TSG-RAN Meeting #13
Beijing, China, 18 - 21, September, 2001

TSGRP#13(01) 0598

Title: Agreed CRs to TS 25.427

Source: TSG-RAN WG3

Figure 5: Outer loop power control information transfer

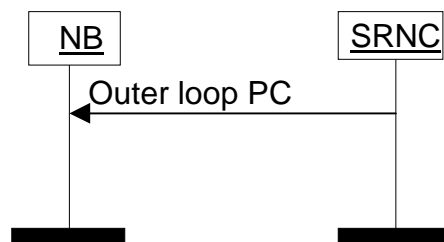
Reason for change:	⌘ Uplink inner loop power control for 1.28 Mcps TDD is closed loop as in FDD. So it is necessary to make the "Outer Loop Power Control" procedure (currently tagged "FDD") in the DCH Frame Protocol applicable for 1.28 Mcps TDD as well, to allow UL SIR Target adjustment via the DCH Frame Protocol.
Summary of change:	⌘ The Outer loop PC information transfer procedure text and payload definition is generalised to include both FDD mode and 1.28 Mcps TDD mode..
Consequences if not approved:	<p>⌘ If this CR is not approved, uplink power control for LCR TDD would not work properly. Deviations between WG3 specs and and WG1 specification 25.224 ch. 5.1.1.4 where power control for LCR TDD is described would remain.</p> <p>The CR is backward compatible to the current version of R99: If the CR is only implemented in one side of the protocol, still all R99 functions work as specified in the current R99 version, without a deviation at message syntax or functional level.</p> <p>This CR has only isolated impact to the current version of R99: If the CR is only implemented in one side of the protocol, still all R99 functions not addressed by this CR work as specified in the current R99 version, without a deviation at message syntax or functional level.</p>

5.4 Outer loop PC information transfer [FDD, 1.28Mcps TDD]

At the reception of the OUTER LOOP PC control frame, the Node B shall immediately update the SIR target used for the inner loop power control [1.28Mcps TDD - of the respective CCH for UL DCHs] with the specified value.

The OUTER LOOP PC control frame can be sent via any of the transport bearers dedicated to one UE. [1.28Mcps TDD - In case of multiple CCHs carrying DCHs, the OUTER LOOP PC control frame can be sent via any of the transport bearers carrying DCHs which belong to the CCH for which the UL SIR Target shall be adjusted.]

Figure 17: Structure of the payload for outer loop PC control frame

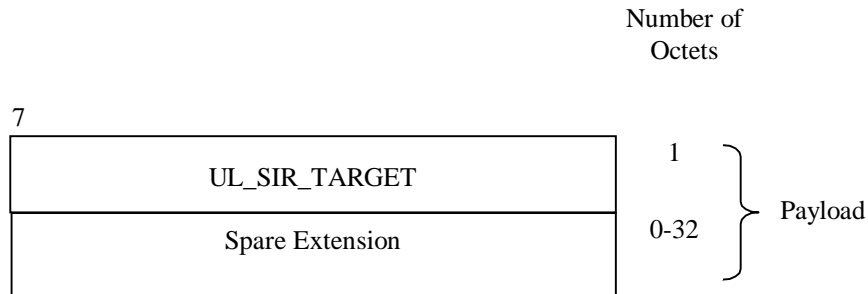
6.3.3.4 UL Outer loop power control [FDD, 1.28Mcps TDD]

Figure 22: Structure of the payload for the Radio Interface Parameter Update control frame

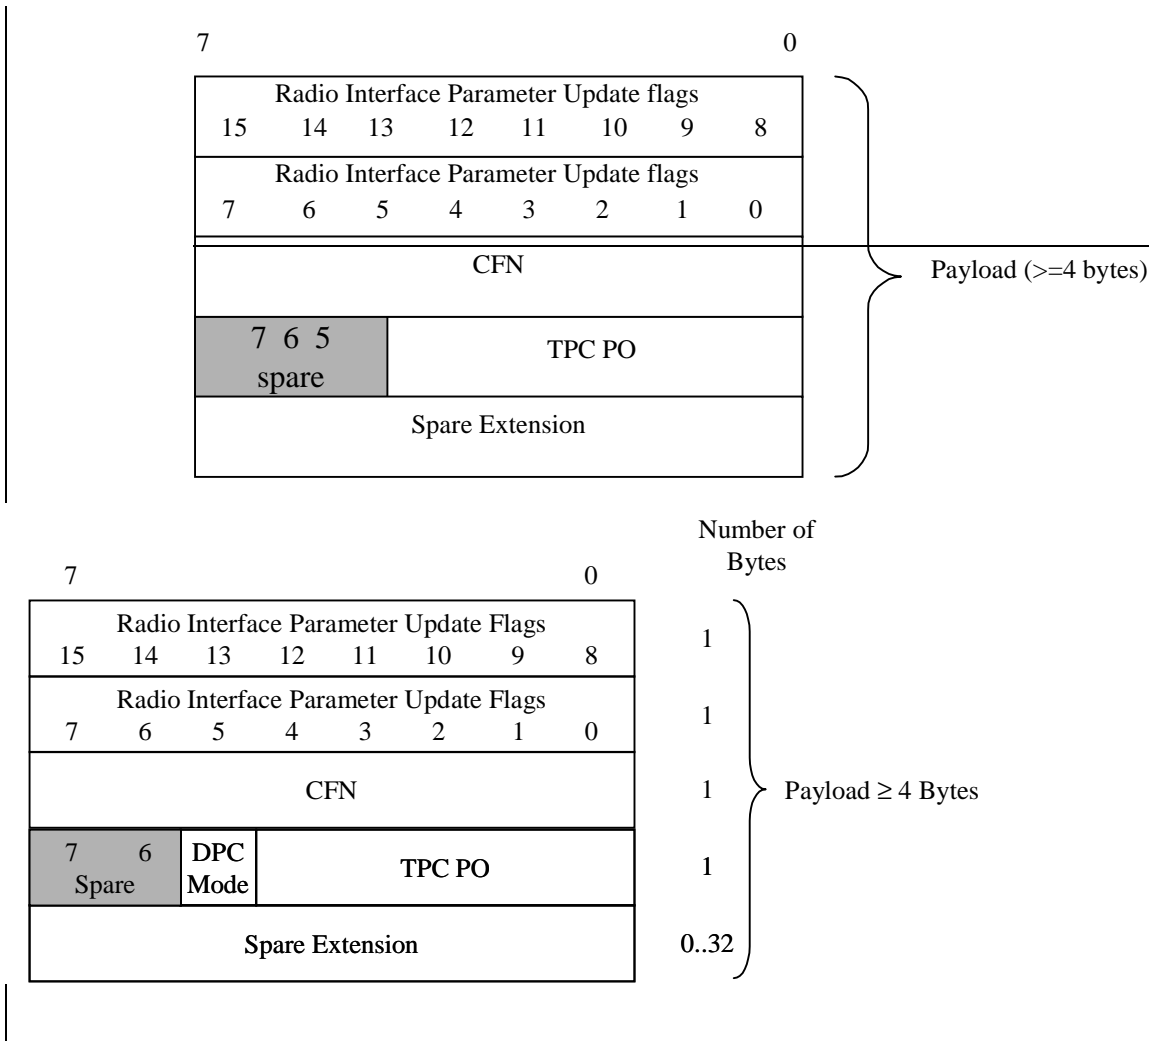
Reason for change:	⌘ The DPC Mode is not present in the figure on Radio Interface Parameter Update control frame structure. Furthermore, some editorial corrections are needed.
Summary of change:	⌘ R1: Addition of a reference to TS 25.214. This is used to specify the behaviour depending on the DPC Mode value. R0: Correction of the figure describing the Radio Interface Parameter Update control frame structure (addition of the DPC Mode), editorial corrections and addition of an abbreviation This change is backward compatible with the Release 99 version of the specification. This correction has an isolated impact on the Radio Interface Parameter Update User Plane procedure.
Consequences if not approved:	⌘ If this CR is not approved, the specification will remain unclear.

The DPC Mode shall be applied as specified in [12].~~Bit 0: The Node B shall estimate the UE transmitted TOC command and update the power in every slot;~~
